# JONES & BEACH ENGINEERS INC.

**RE: Response Letter – Peer Review**  
**635 Sagamore Ave, Portsmouth, NH**  
**Tax Map 222, Lot 19**  
**JBE Project No. 18134.1**

We are in receipt of comments from Eric Weinrieb, P.E., Altus Engineering dated June 4, 2024. Review comments are listed below with our responses in bold. In addition to the below comments, the City DPW requested two changes to the plans and drainage model at an on-site meeting with Mike Garrepy of 635 Sagamore Development, LLC on July 24<sup>th</sup>, 2024 while the new test pits were being dug.

**ANTI-SEEP COLLAR**

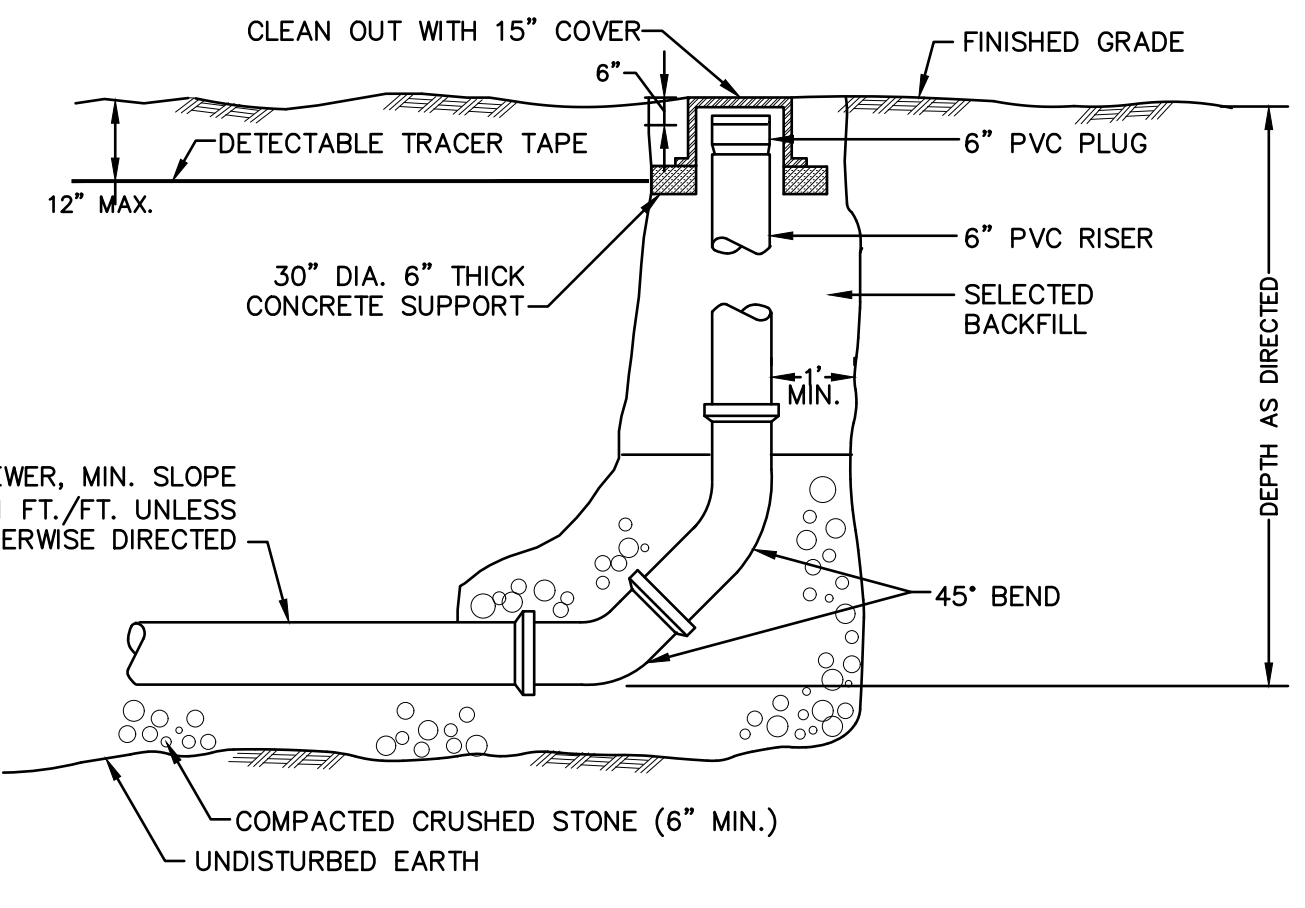
15. *The notes on the anti-seep collar detail conflicts with locations shown on the plans. Clarification is needed.*

**RESPONSE:** The Anti-Seep Collar detail states that anti-seep collars shall be placed 15' and 25' downstream of a culvert inlet unless otherwise specified, AND that they shall be placed on both sides of a clay core. The outlet culvert from the proposed bioretention pond, which passes through a clay core berm, is only 20' long. Therefore, anti-seep collars are proposed on both sides of the clay core berm. In our judgement there is no reason to place another one 5 feet from the outlet headwall.

**CLAY CORE BERM**

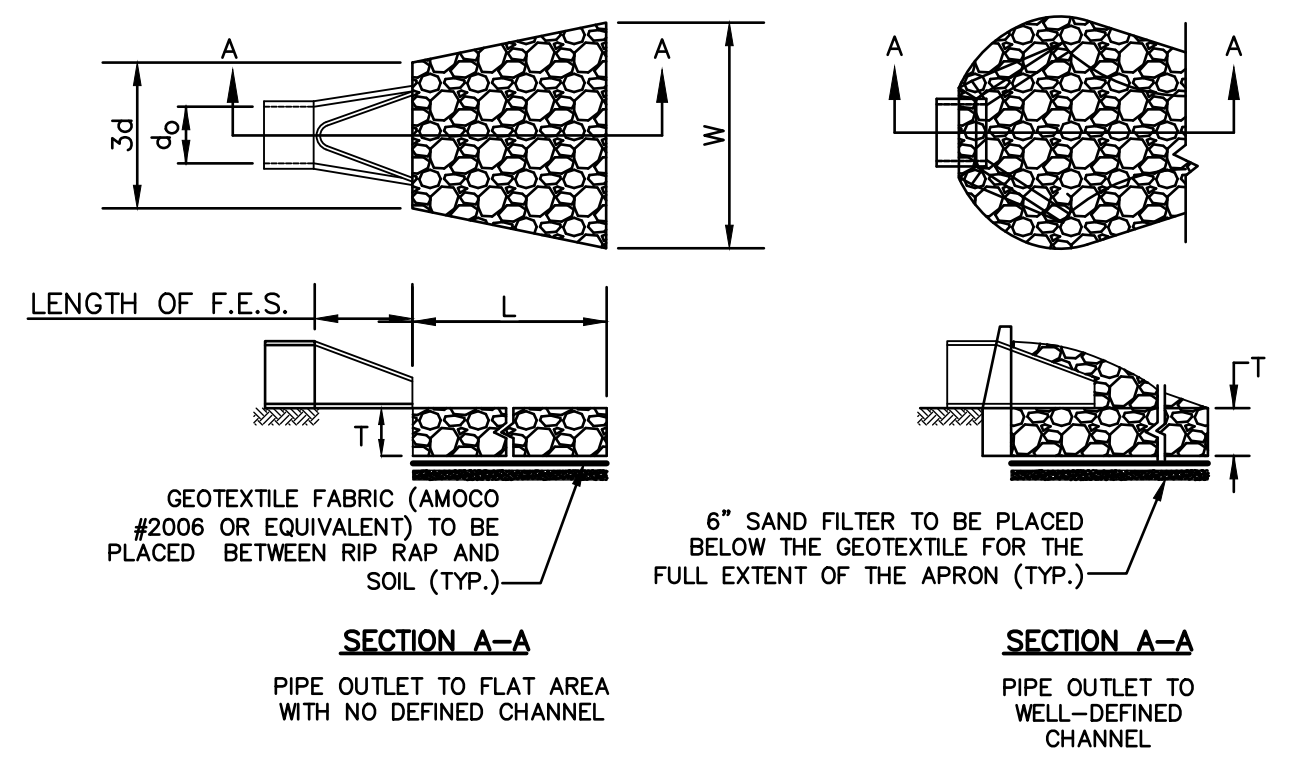
16. It is presumed that the clay core berm will interface with exposed ledge. The detail should clearly note how the interface will be constructed to ensure that there is no seepage.

**RESPONSE: Note #5 has been added to the clay core berm detail on Sheet D4, stating that ledge shall be removed to at least 2' outside of and below the clay core.**
